MEMORANDUM

Re: Special Permit – *The Street Redevelopment*

*Village of Chestnut Hill, MA  
The Street Redevelopment  
Permitting Plans  
Dated: June 10, 2016  
Revised: August 25, 2016  
Prepared by: Tighe & Bond*

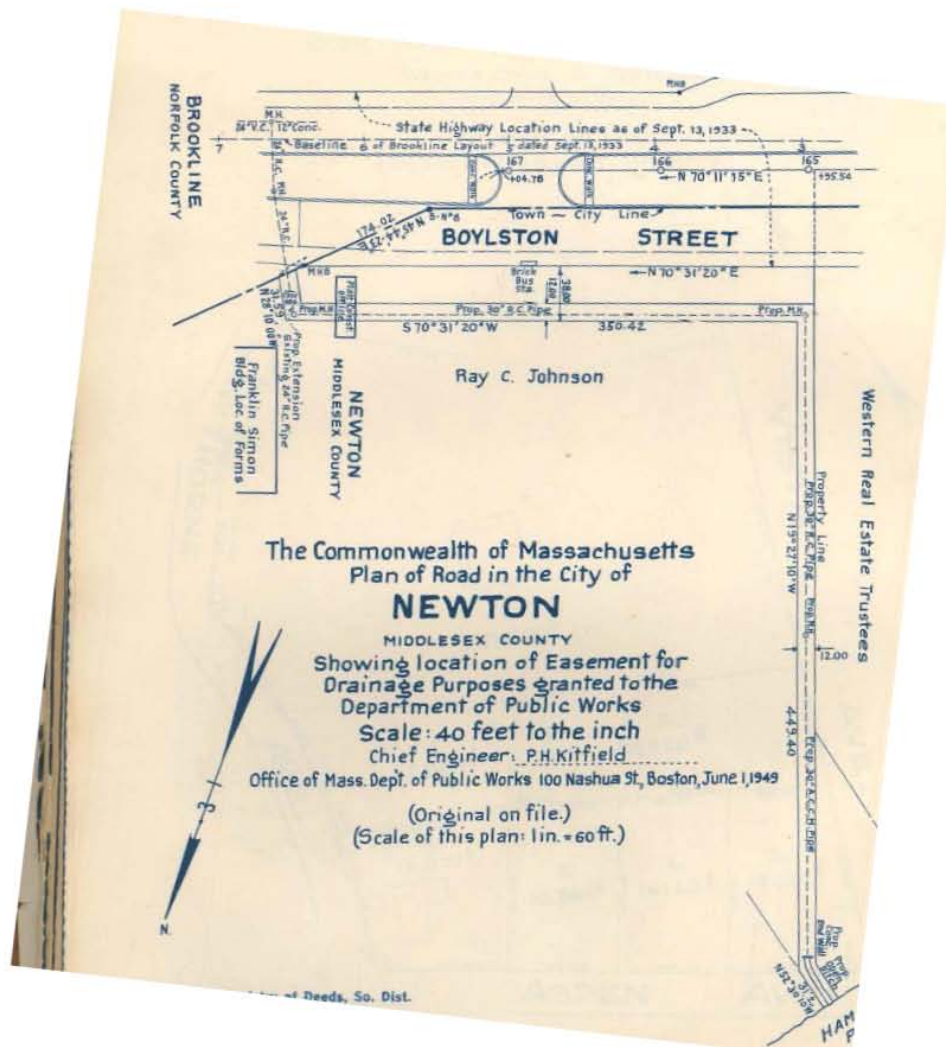
Two of the proposed buildings near Hammond Pond are to be sited juxtaposed to a MassDOT drainage easement that contains a 30" diameter corrugated steel pipe and outfall. This pipe collects a large portion of runoff off Rte. 9 from the Brookline/Newton corporate limits down to the low point of the site; (see photo below). Portions of the proposed buildings will overhang the drain pipe, and the docks & boardwalk will be built directly over this easement and pipe; this is a concern as it will limit MassDOT from future access and maintenance. As a courtesy the applicant should contact MassDOT District 6 who has jurisdiction over the easement for review and comment. This office should be copied in all correspondence to MassDOT. A site section should be developed that shows the two proposed buildings, the docks, boardwalk, the easement, and the existing 30" corrugated metal drain pipe; and how access for maintenance will be addressed.
